SUBJECT: FY13 Joint Routine Inspection of Completed Works, Flood Damage Reduction Project, Genesee River and Dyke Creek, Wellsville, New York (09/24/13)

**Subject: FY13 Joint Routine Inspection of Completed Works, Flood Damage Reduction Project, Genesee River and Dyke Creek, Wellsville, New York (09/24/13)**

Attachment "A" - Genesee River - Left Bank Levee and Channel - Summary of Deficiencies and Recommendations

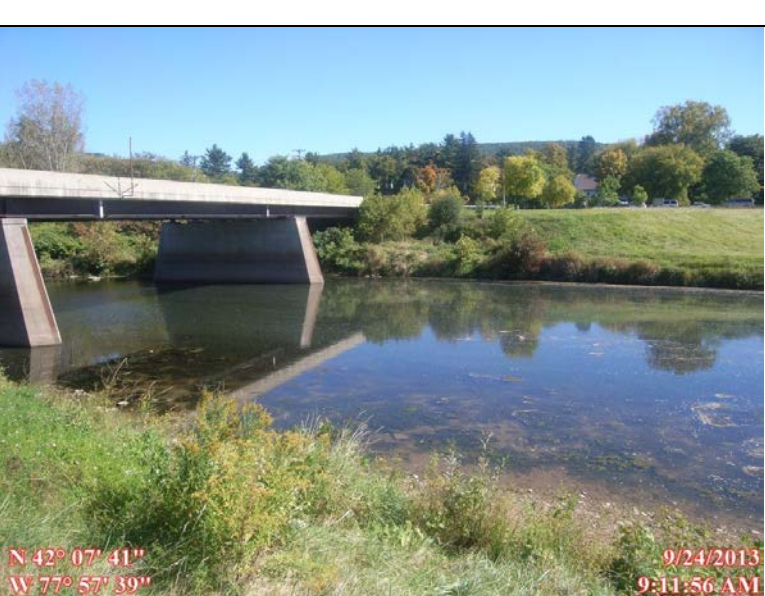
<p><b>Inspect ID:</b> N21L_2013_a_0021 <b>Title:</b> USACE_CELRB_N21L_2013_a_0021_1.jpg <b>Rated Item:</b> 2. Shoaling (sediment deposition) <b>Caption:</b> Rating: Minimally Acceptable; <b>Remarks:</b> Shoaling in drainage inlet channel (photos taken from the middle of inlet channel); Station_1: 97+00</p>
	<p><b>Inspect ID:</b> N21L_2013_a_0021 <b>Title:</b> USACE_CELRB_N21L_2013_a_0021_2.jpg <b>Rated Item:</b> 2. Shoaling (sediment deposition) <b>Caption:</b> Rating: Minimally Acceptable; <b>Remarks:</b> Shoaling in drainage inlet channel (photos taken from the middle of inlet channel); Station_1: 97+00</p>

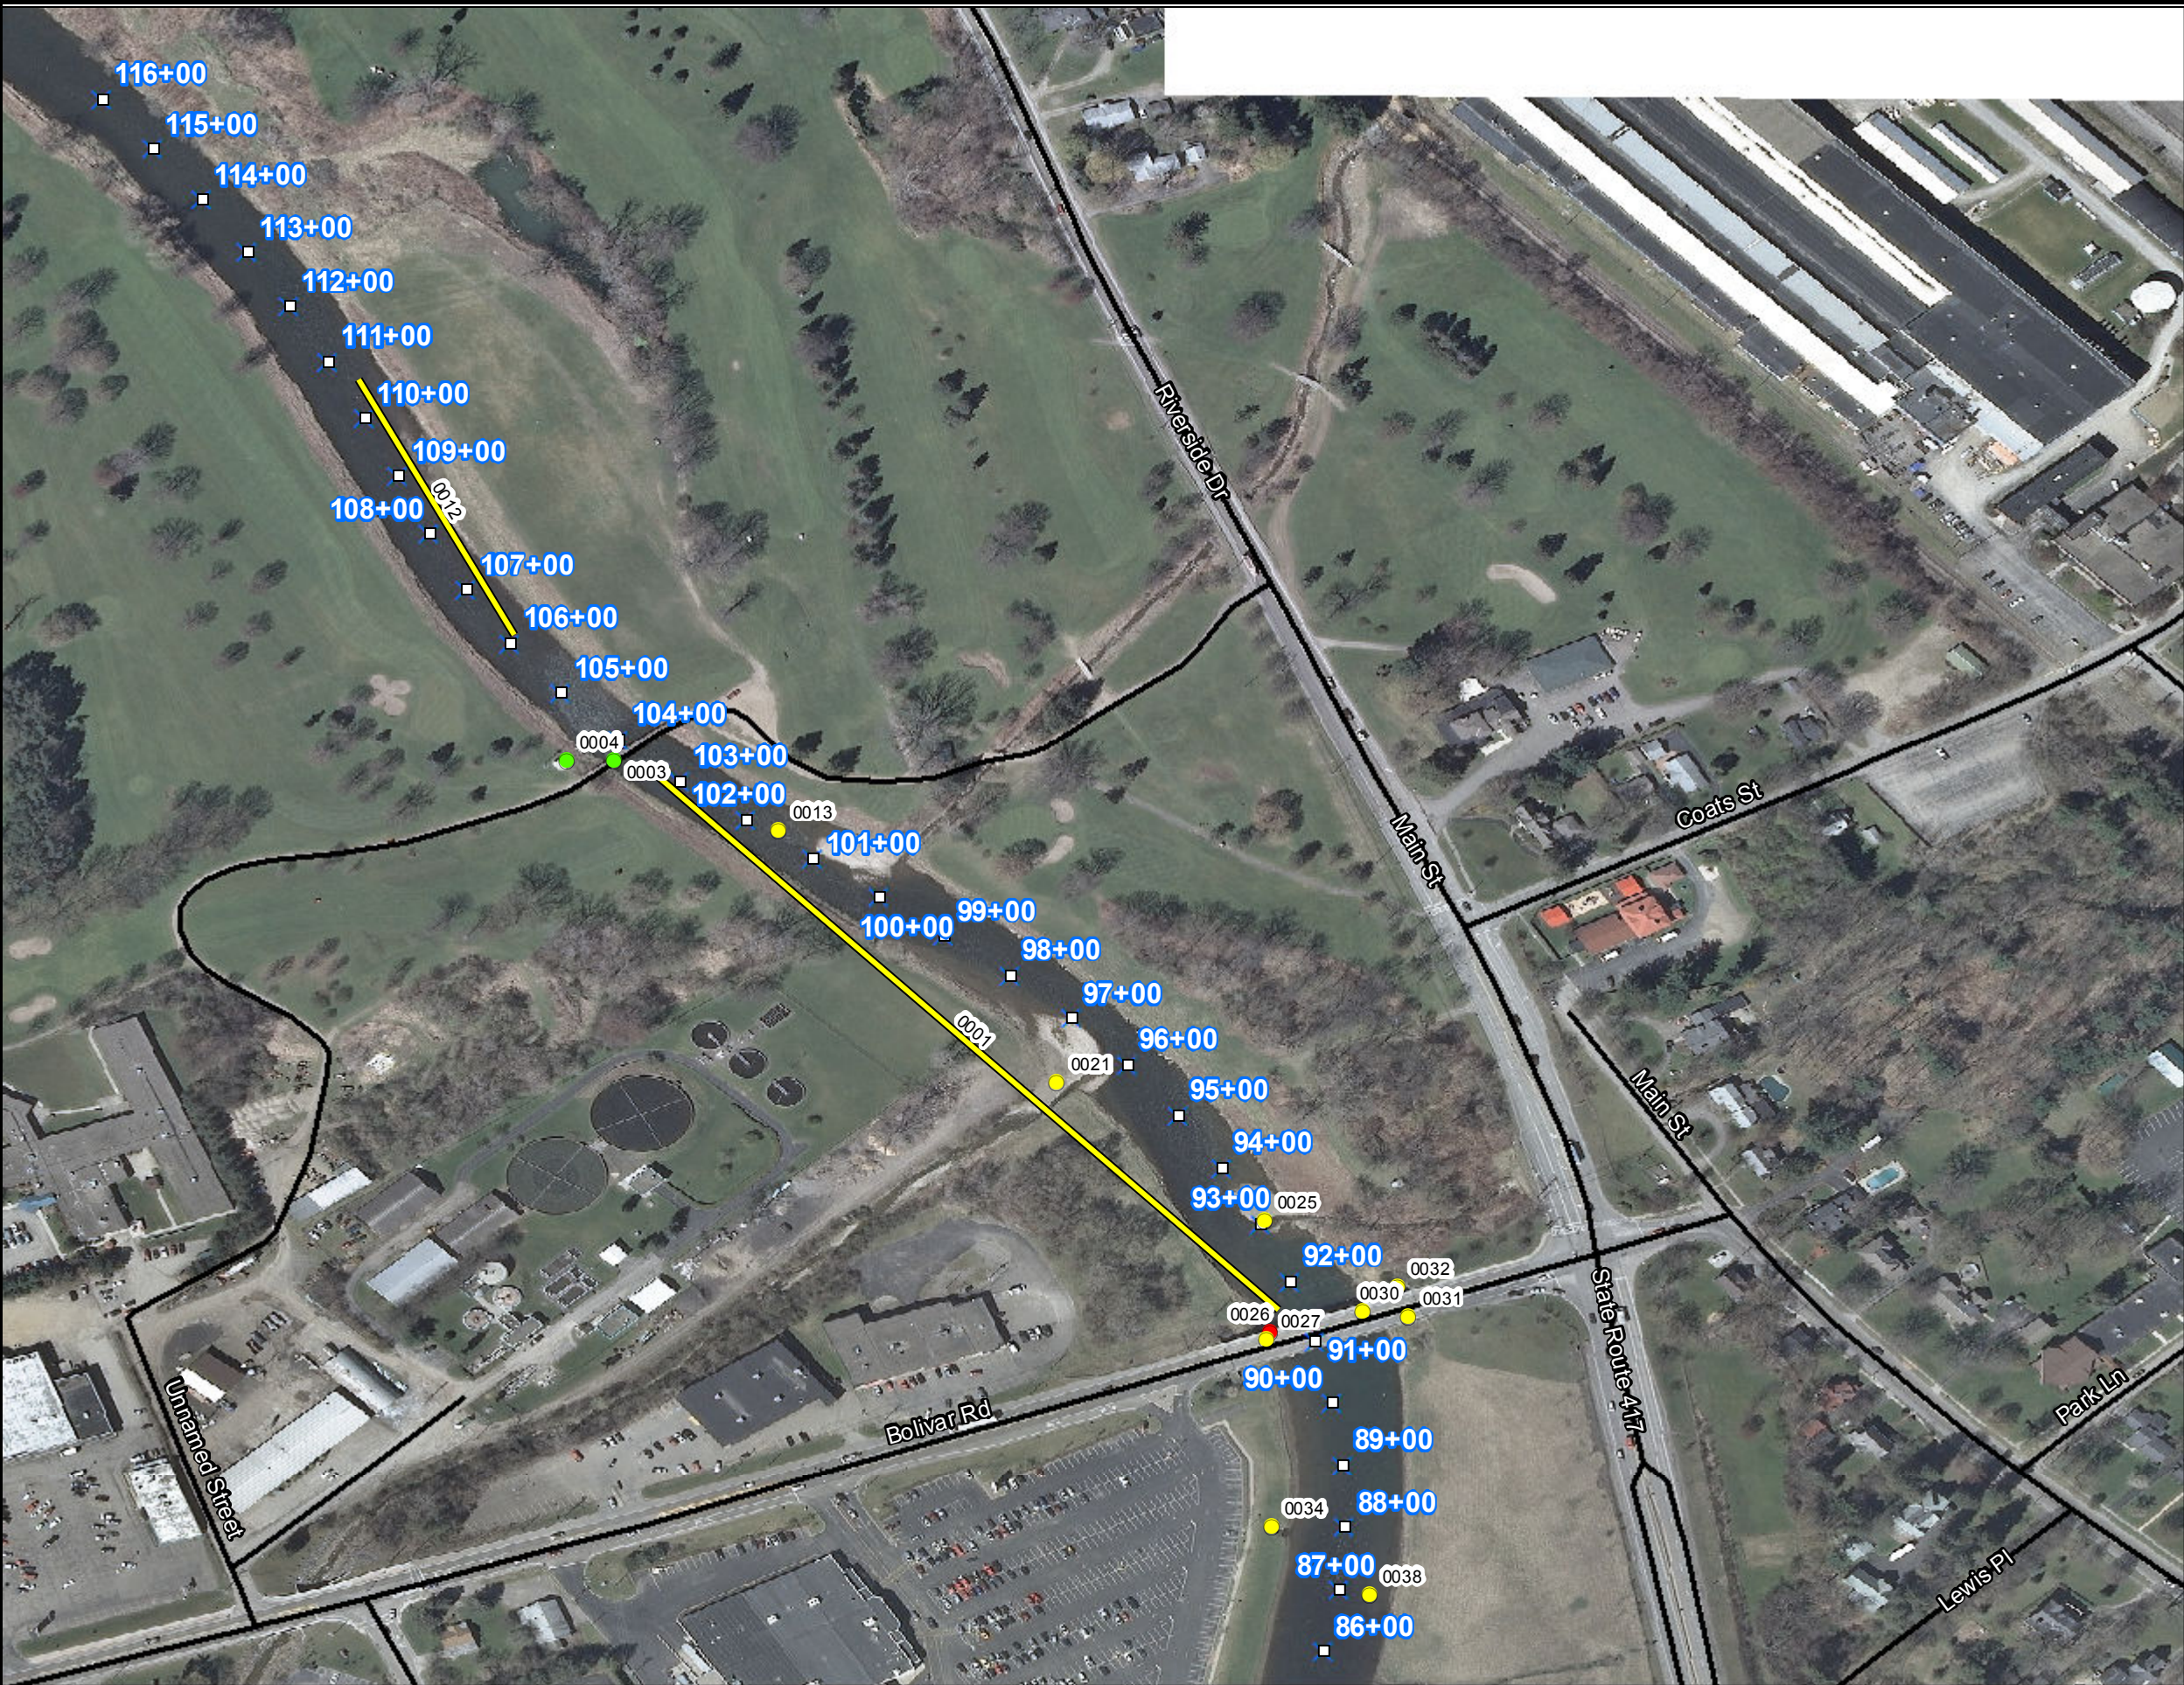
<p>N 42° 07' 04" W 77° 56' 29" 9/24/2013 2:58:00 PM</p>	<p><b>Inspect ID:</b> N21R_2013_a_0057 <b>Title:</b> USACE_CELRB_N21R_2013_a_0057_1.jpg <b>Rated Item:</b> 11. Revetments other than Riprap <b>Caption:</b> Rating: Unacceptable; Remarks: Unwanted vegetation in concrete; Station_1: 12+00; Station_2: 18+00</p>
 <p>N 42° 07' 05" W 77° 56' 43" 9/24/2013 3:21:12 PM</p>	<p><b>Inspect ID:</b> N21R_2013_a_0077 <b>Title:</b> USACE_CELRB_N21R_2013_a_0077_1.jpg <b>Rated Item:</b> 11. Revetments other than Riprap <b>Caption:</b> Rating: Minimally Acceptable; Remarks: Unwanted vegetation between concrete joints both banks; Station_1: 6+00</p>
